# Sub Regional RTEP Committee: Western Dayton Supplemental Projects

# Cancellation to the Existing Supplemental Projects

**Project Stage:** Cancellation SRRETP-W meeting - 05/16/2025

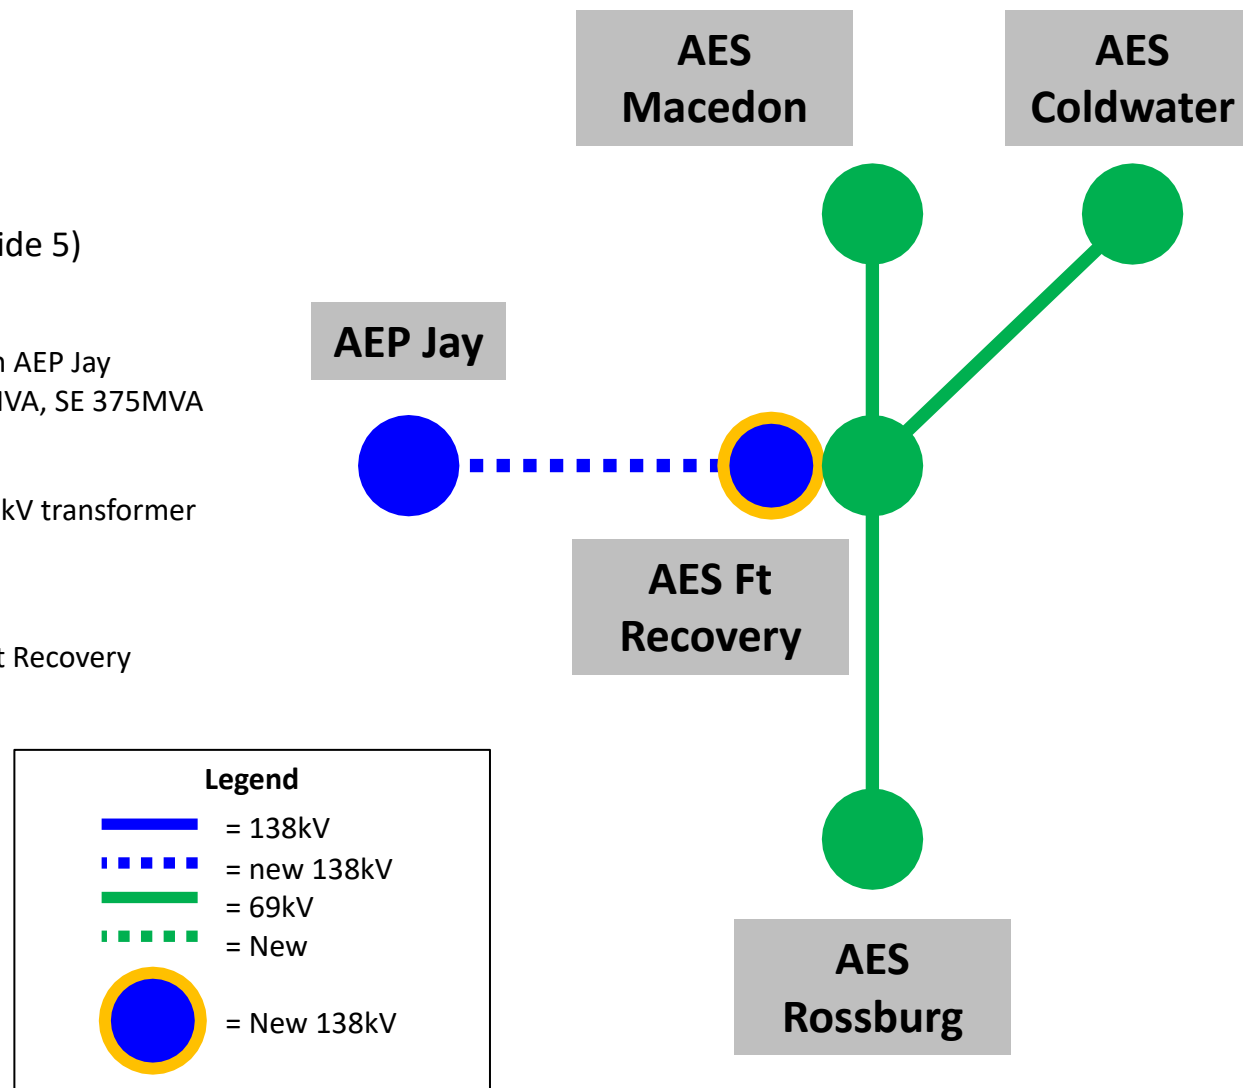
- **s0326 - Jay to Ft Recovery 138kV Line** : Build a new 22 mile 138kV line from AEP Jay Substation to AES Ft Recovery using 1351 ACSR conductor. Ratings SN 301MVA, SE 375MVA

- **s0327 - Ft Recovery 138kV/69kV Transformer** : Install new 200MVA 138/69kV transformer and a 138kV breaker at AES Ft Recovery substation.

- **s0328 - Ft Recovery Cap Bank**: Install new 30MVAR capacitor bank at AES Ft Recovery substation.

**The Reason for Cancellation:** Solution is addressed by s3375
